Modification 2 of Redfern Mixed Use Co-Living Housing Development

State Significant Development Modification Assessment Report (SSD-32275057-Mod-2)

June 2026

Figure 3 | Typical Level 1 to 4 internal building separation (Source: Applicant's RtS, 2026)

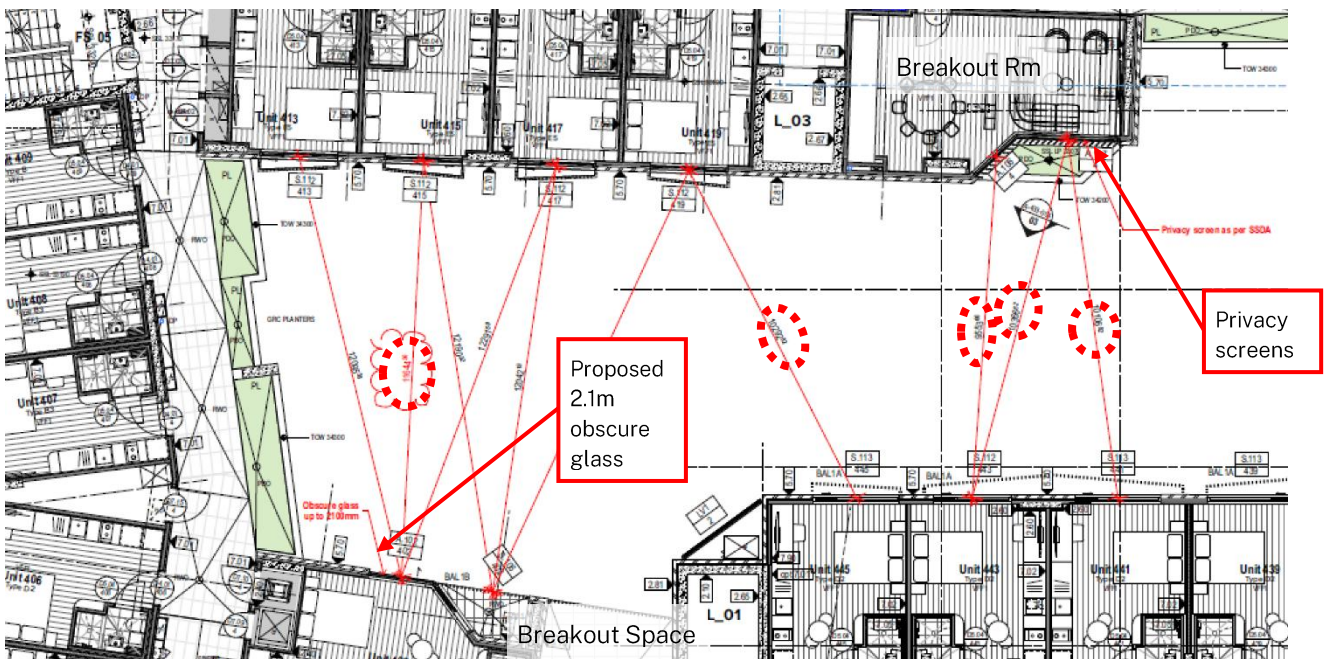
Council noted that changes to the co-living rooms at the northern end of the courtyard do not meet the required 12 m minimum building separation of the ADG. Council advised that that Level 1 rooms should be provided with higher window-sill heights and privacy treatments for courtyard and street facing rooms as required by Condition B3.

In response, the Applicant submitted a typical Level 1 to 4 modification plan of the internal courtyard area with dimensions showing majority of the co-living rooms achieve the required minimum separation distances of the ADG, except those identified in

Figure 3. For units with reduced building separation, the Applicant proposes the inclusion of privacy screens and obscure window glazing.

The Department has carefully reviewed the proposed modifications and considers the changes are minor and would continue to support a reasonable level of privacy for residents because:

The Department considers that the Applicant has adequately demonstrated that the proposed modifications will not result to visual privacy impacts and continue to support acceptable levels of visual privacy consistent with the ADG subject to Condition B3 of the consent.

The Department is satisfied that Condition B3 Design Modifications-Privacy Treatments of the development consent will continue to apply in requiring the Applicant to submit revised plans to the satisfaction of the Certifier demonstrating operable external privacy treatments for courtyard facing rooms and lowest level rooms facing Cleveland/Eveleigh/Woodburn Streets.
